MANDATORY SERVICE BULLETIN

NUMBER: SB-013

SUBJECT: ELECTRICAL SYSTEM; GENERATOR CIRCUIT BREAKER CHECK PROCEDURE

Generator Circuit Breaker Check Procedure

Remove screws located at arrows

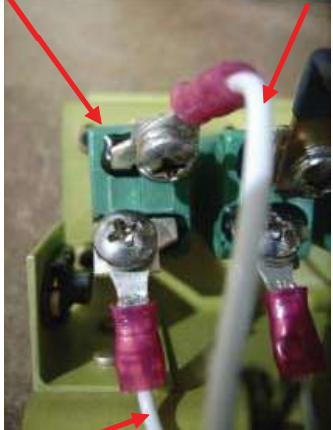
Remove the circuit breaker panel by removing the forward middle floor panel and then extracting the 12 screws that secure the circuit panel in place. (3 located on the sides, 3 on the top, and 3 on the bottom.)
